Legalelectric, Inc.

RE: The Prehn Family & NoCapX 2020 Scoping Comment
Wilmarth-N Rochester-Tremval a/k/a Mankato-Mississippi Transmission Line
PUC Dockets CN-22-532 and TL-23-157

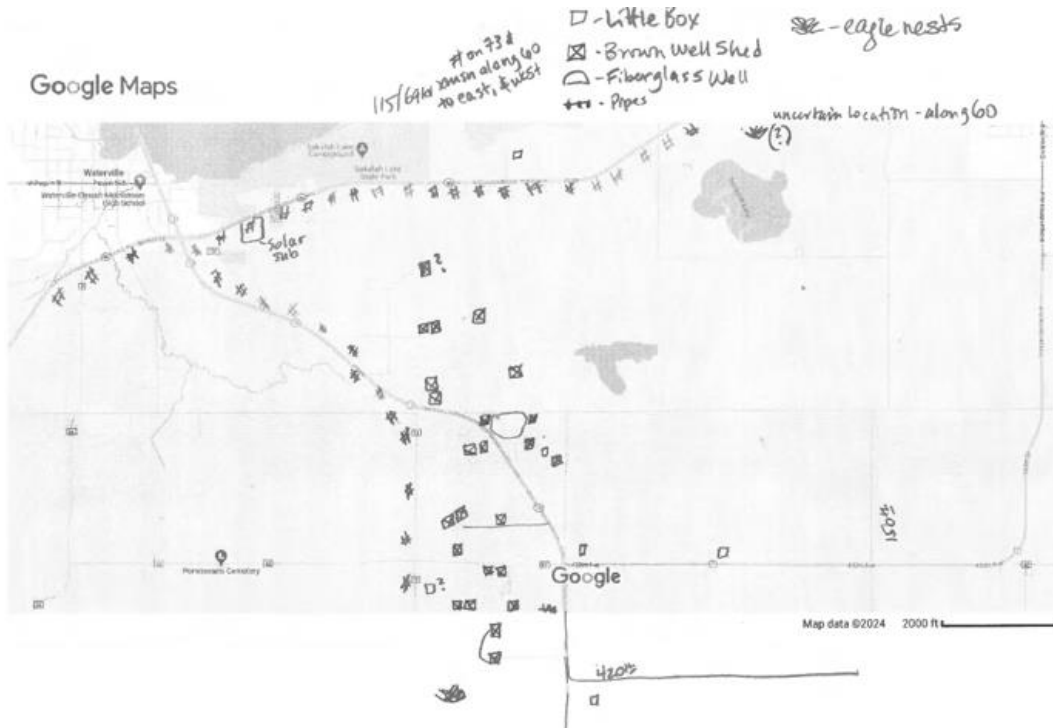
A map from the initial DNR permitting of the underground storage was included in the initial Prehn comment, and Xcel had the opportunity to review and mark it on its Segment 1 Map 8 map, and this was not done. These maps are from the mid-60s and 1972. The underground storage was expanded post 1972. I'd guess CenterPoint would provide a current map.

This, is the very rough map compiled by the Prehns in an afternoon of area reconnaissance:

The EIS, with the help of CenterPoint and the Prehn’s map as guidance, must show the full extent of the CenterPoint natural gas dome on a map, the office and water treatment plant, and all of the wells and monitors in both of the routes, with particular designation for those wells and potentially affected areas and document its understanding of potential impacts.

DETAILED MAPBOOK: SEGMENT 1 (REVISED)

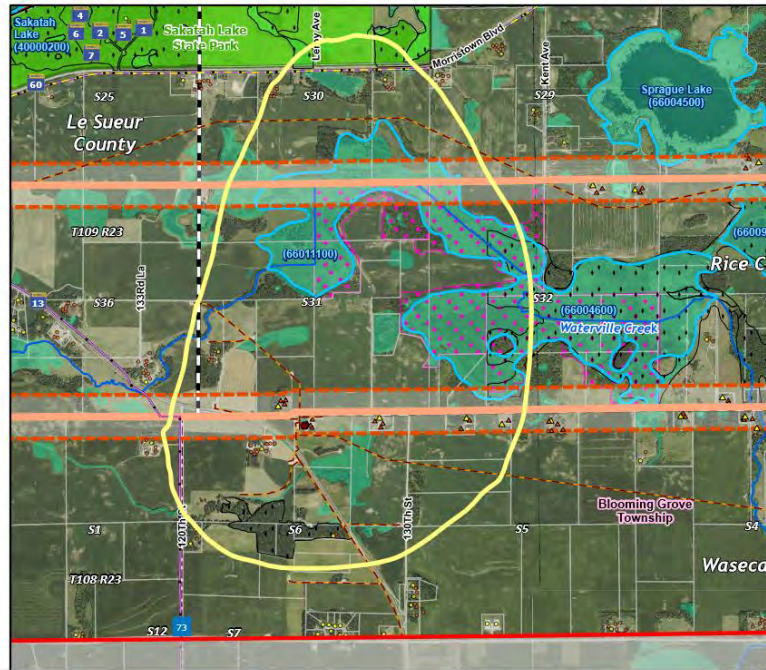
Xcel states that it has marked on its April 2024 revised map gas wells within 500 feet of the proposed line, identifying those wells with a black dot, but this writer cannot see any black dots on the map. Further, on April 2-24 Revised Segment 1 Map 8, there is no depiction of the extent of the natural gas storage dome, which is loosely represented by the yellow circle above and below. Xcel's revised map does show a large red dot at the CenterPoint office and water treatment plant along Highway 13, but again, that is just the office and water treatment facility, and not the gas dome. There is no depiction of the extent of the 13.25 square mile natural gas storage dome. By any measure, it's major infrastructure and should be shown on the map.

This is the Xcel's April 29, 2024 map with this writer's approximation of the dome boundary:

DETAILED MAPBOOK: SEGMENT 1 (REVISED MAY 6TH, 2024)

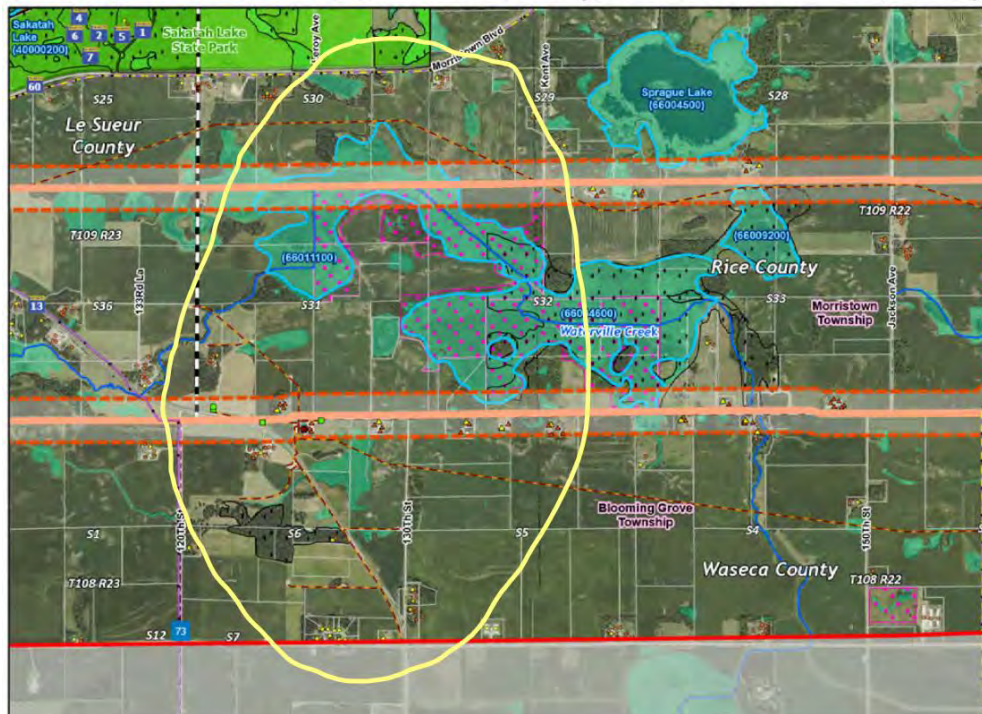
The May 6 revised map does show wells with green squares, but there are no wells marked on the northerly route, and there may well be some there. Again, there's no depiction of the gas dome, again with this writer's rough approximation of the dome boundary:

G. ACTIVE KARST IS IN THE S.E. AREA PROPOSED FOR THIS PROJECT

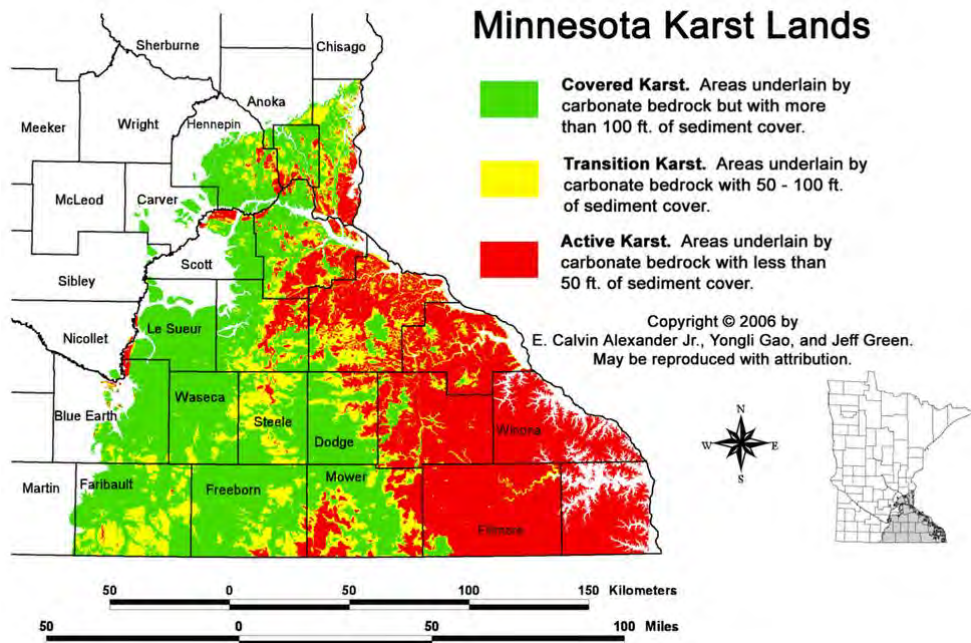
The EIS must map the active and transitional karst areas in the corridors where transmission structure foundations could be unstable³.

H. THE EASTERN ENDPOINT OF THE CHESTER LINE MUST BE DISCLOSED

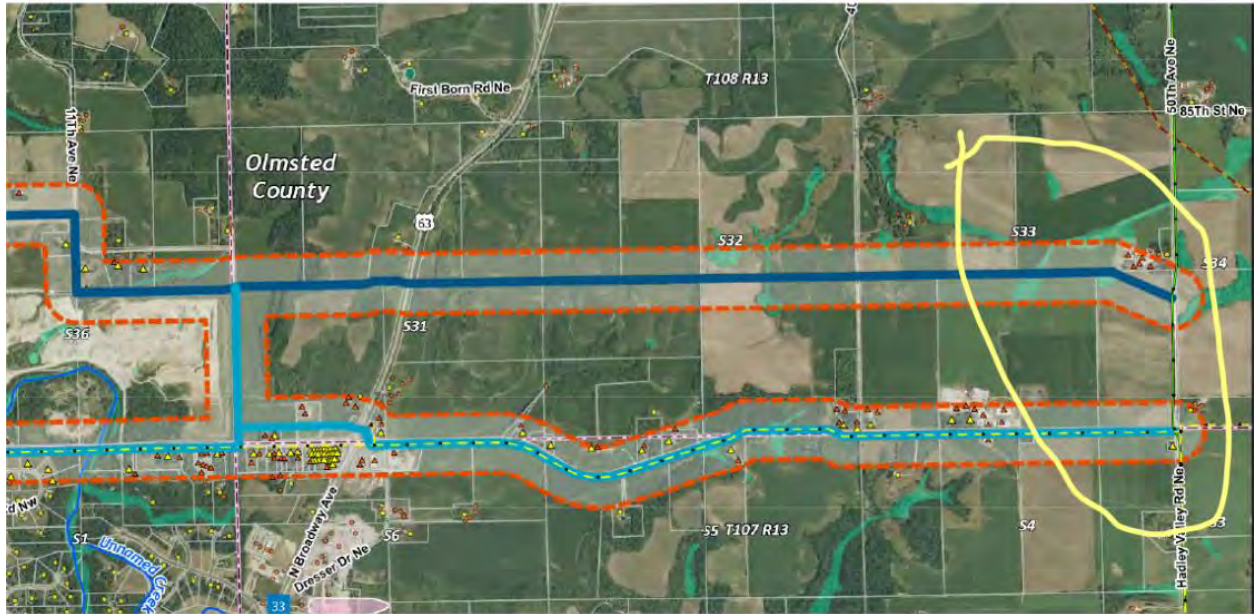
The EIS must disclose where the eastern end of the project extends beyond what is shown on the maps, which is two routes/corridors stopping at Hadley Valley Road N.E./50th Avenue N.E. where there is no substation or terminus of any sort. How the project transitions beyond what is on that map may well have, should have, an impact on what route is chosen. If a route is chosen without regard for how the line is routed beyond the map, it will lock that eastern “beyond” section of the 161kV project into a route that is not feasible or not recommended. The

Commission cannot make an informed decision without the remainder of the 161kV project in the record.
